Request	-	Special Use Permit for Modifications to Major Utility
Location	-	3900 N Summit Street
Applicant + Owner	-	City of Toledo 1 Government Center Suite 2250 Toledo, OH 43604
Engineer	-	Jones & Henry Engineers, LTD 3101 Executive Pkwy Toledo, OH 43606
Architect	-	Thomas Porter Architects 8 N St. Clair St Toledo, OH 43604

The staff recommends that the Toledo City Plan Commission recommend approval of SUP-7004-23, Special Use Permit for Modifications to Major Utility at 3900 Summit Street to the Toledo City Council for the following two (2) reasons:

SPECIAL USE PERMIT  
TOLEDO CITY PLAN COMMISSION  
REF: SUP-7004-23  
DATE: September 14, 2023  
TIME: 2:00 P.M.

CHLORINE BUILDING  
ARCHITECTURAL  
EXTERIOR ELEVATIONS  
CITY OF TOLEDO - BAYVIEW WASTEWATER TREATMENT PLANT  
L-65 CHLORINATION AND DECHLORINATION IMPROVEMENTS

SITE PLAN

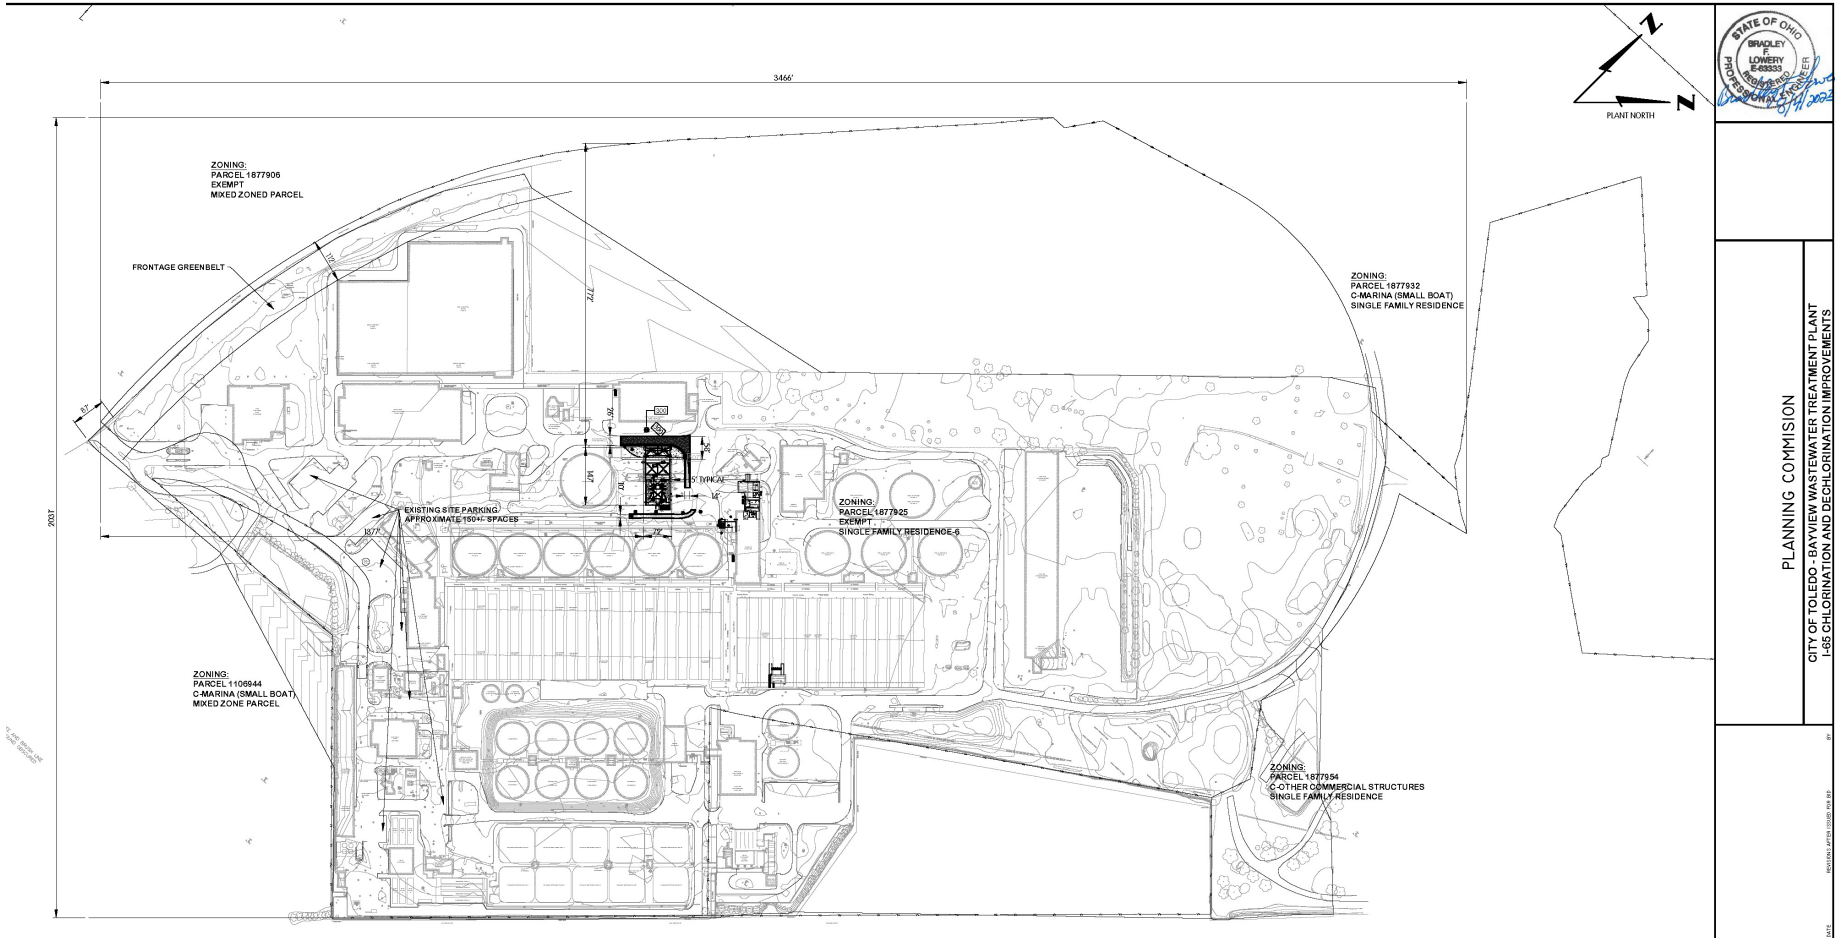
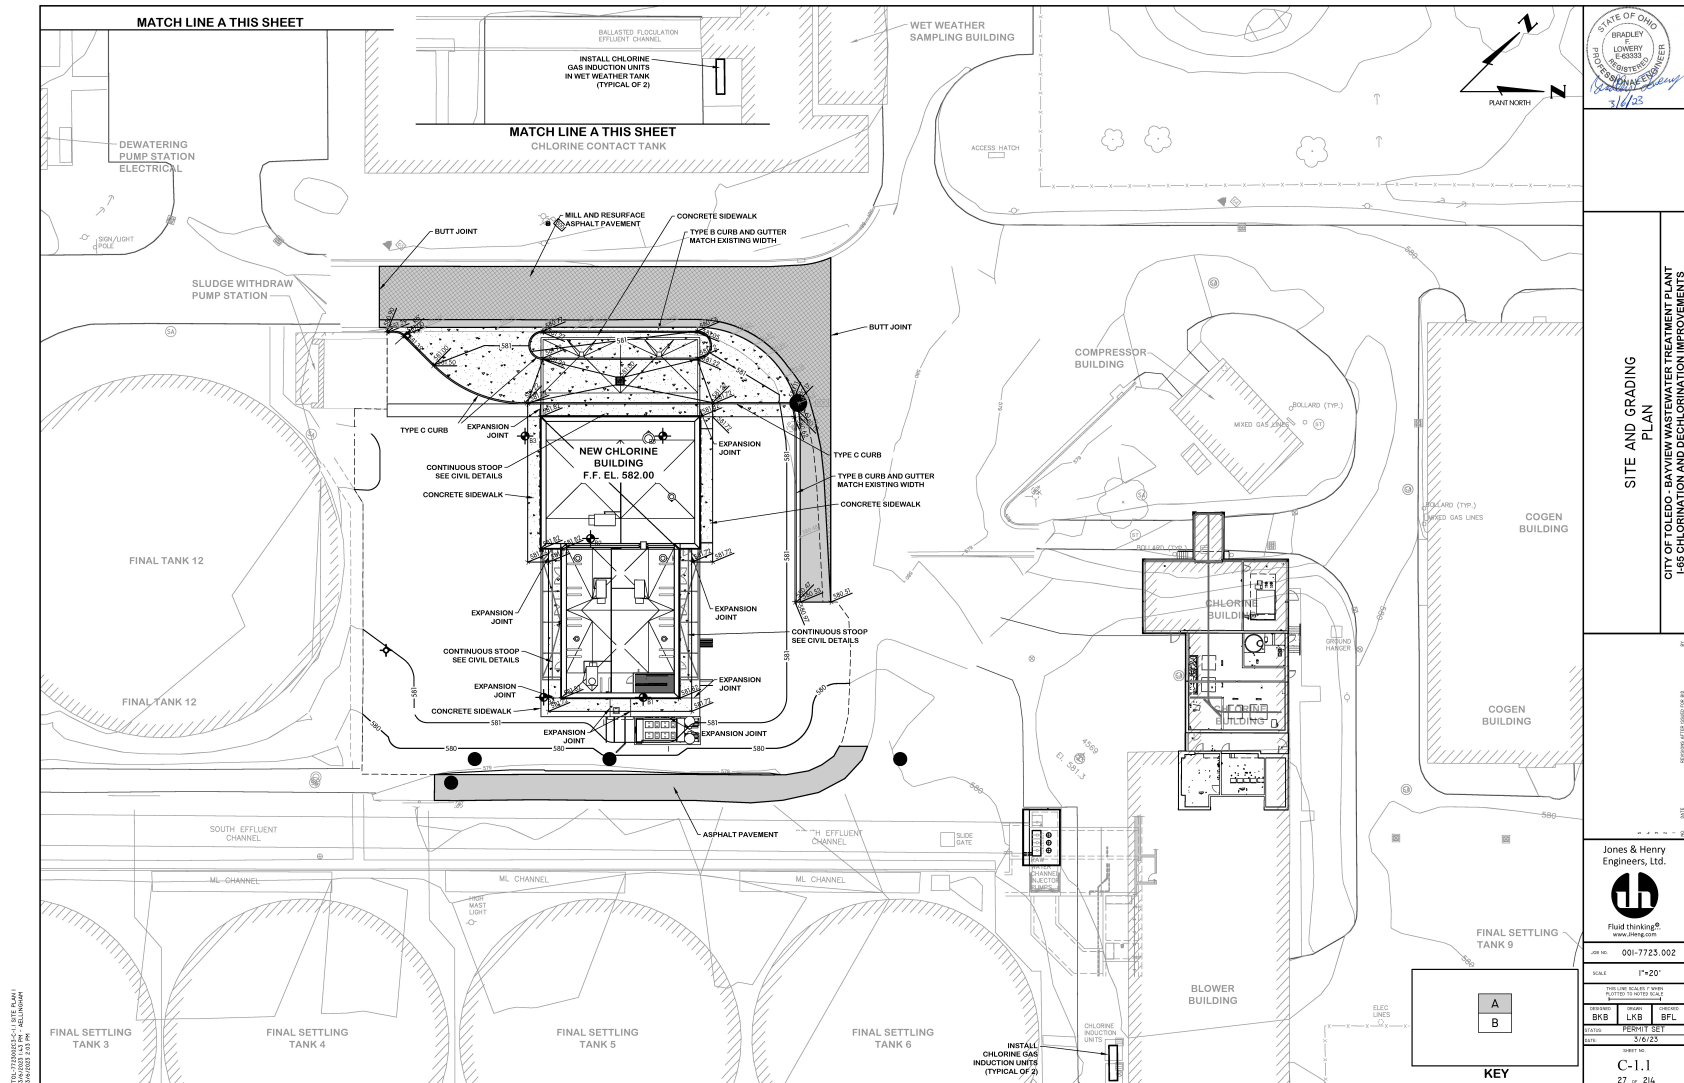
6. Approved Premises identification is required.
7. Key box(s) for access to buildings and areas restricted by fences, gates, etc.
8. Fire apparatus access roads shall have an unobstructed width of not less than 20'. Paved road south east of the new building from where it leaves the main paved area to its dead end.

9. Fire apparatus access roads shall have an unobstructed vertical clearance of not less than 13'6".
10. Dead end fire apparatus access roads in excess of 150' shall be provided with an approved turn around area. Paved road south east of the new building from where it leaves the main paved area to its dead end.

20. Existing parking shall adhere to the standards of TMC§1107.1700 – Accessible parking for physically disabled persons. **A revised site plan shall list the total quantity of accessible van and car spaces.**

23. Off-street parking and loading spaces, parking lots, maneuvering areas, aisles and driveways must be surfaced with concrete, bituminous asphalt, or other dust-free material other than gravel or loose fill, and be graded to drain all surface water towards the interior of the parking lot. **Acceptable as depicted on site plan.**

- a. Four (4) additional two-inch caliper trees are required per TMC§1108.0205. **Not acceptable as depicted.**
  - b. The location, height and materials for any new and existing fencing to be maintained. Per TMC 1108.0203(H), the fencing shall be at least 6 feet high, but not higher than 10 feet and may be shadow box, chain link with slats, stockade, or another type approved by the Plan Commission.

- d. No rip-rap, crushed stone, concrete or other impervious materials may be exposed above the average pool elevation for any retention pond.
  - e. The location, number, height, diameter and species of any materials to be planted and maintained, as well as the location and number of any existing trees to be retained, trees, shrubs, and landscape materials shall meet the standards included in TMC 1108.0400 Landscape Materials Standards. **Shall be submitted on a revised site plan.**

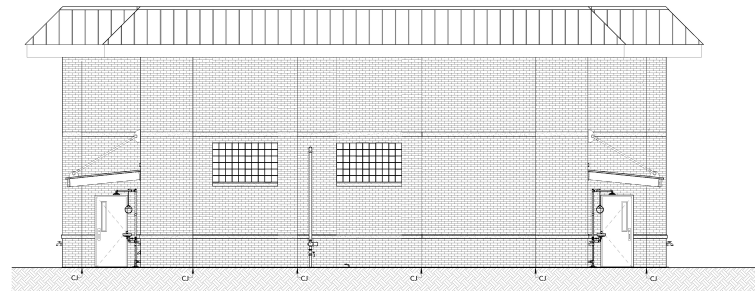
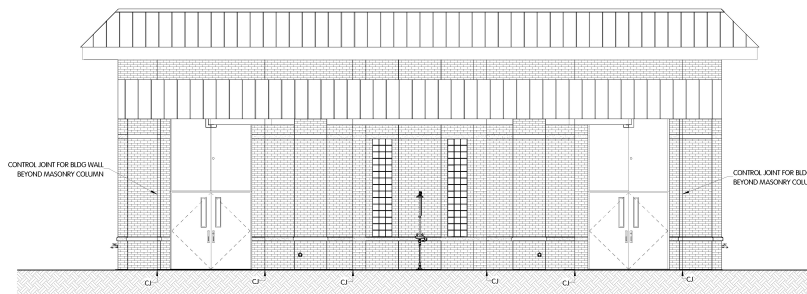
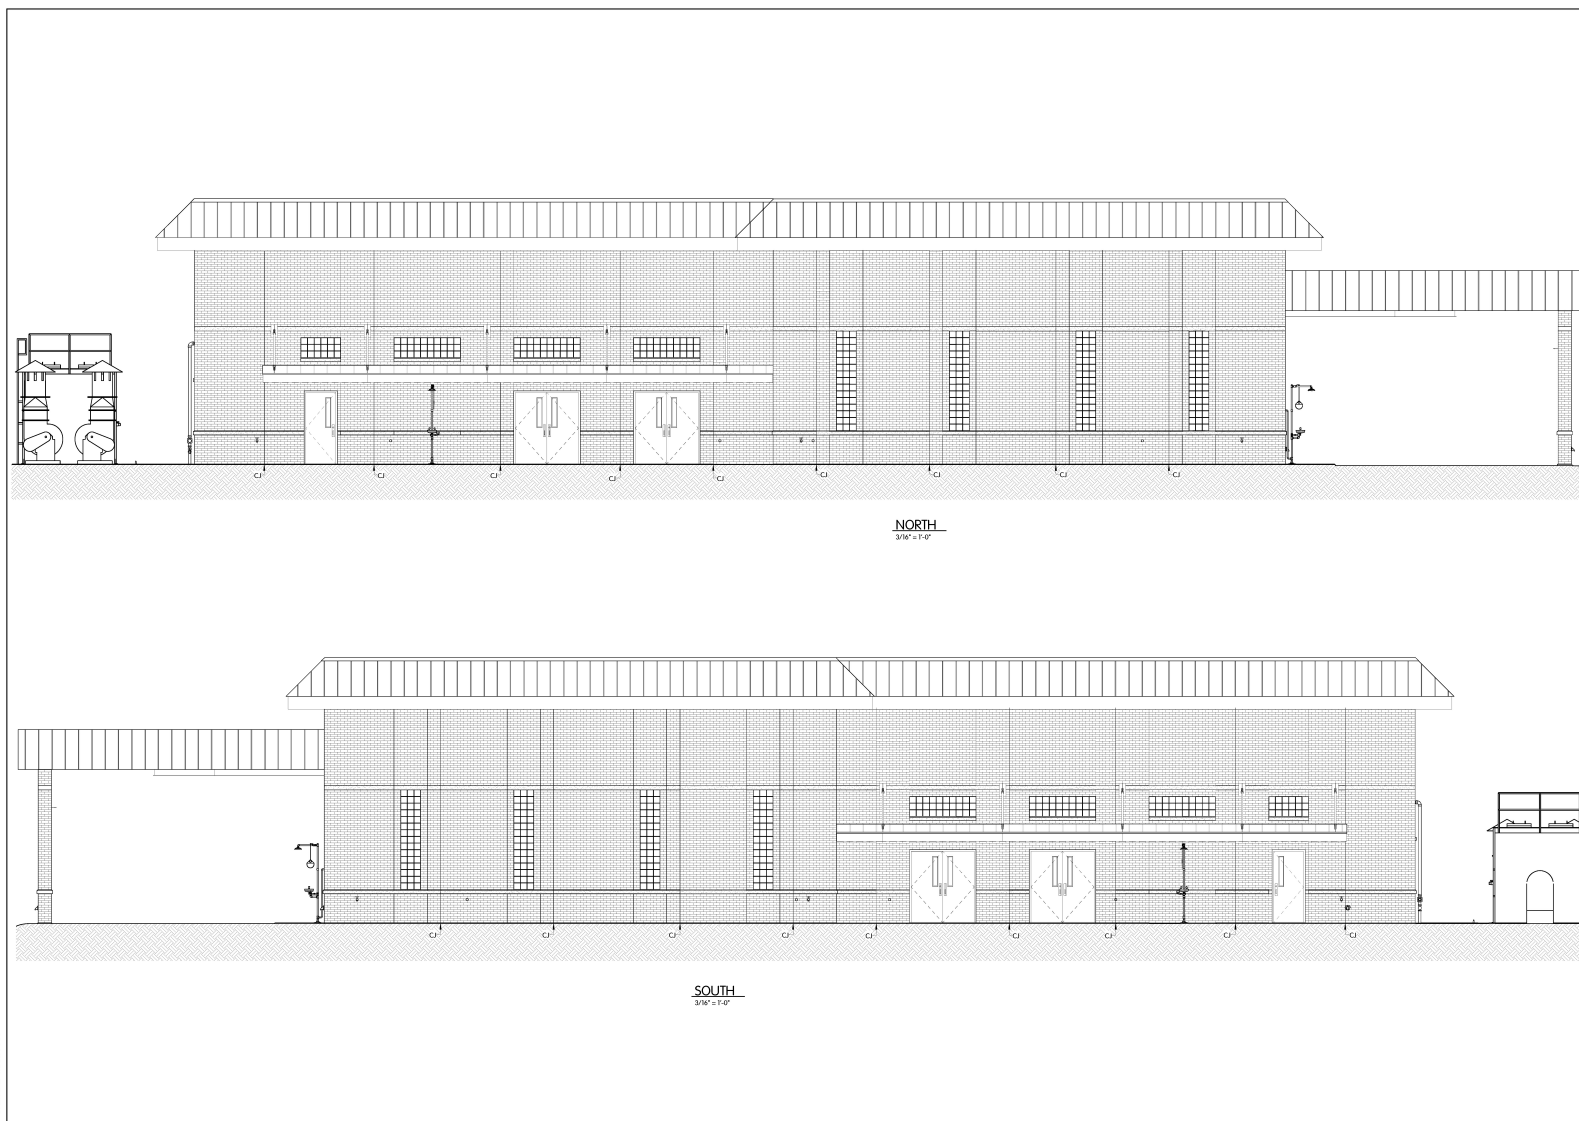
Industrial buildings are required to utilize low-reflectance, subtle, neutral, or earth tone colors per TMC§1109.0402. The proposed chlorination building is a one-story masonry veneer building with glass block windows, fiberglass exterior doors and frames, pre-finished standing seam metal canopies/parapet accents, and a pre-finished flush metal panel clad covered drive approach. The masonry veneer color scheme shall be a red blend and the seam metal copies a blue-finish to match surrounding structures.

25. All structures shall utilize durable building materials such as brick, stone, metal, or concrete. **Proposed materials on chlorination building area acceptable as depicted.**
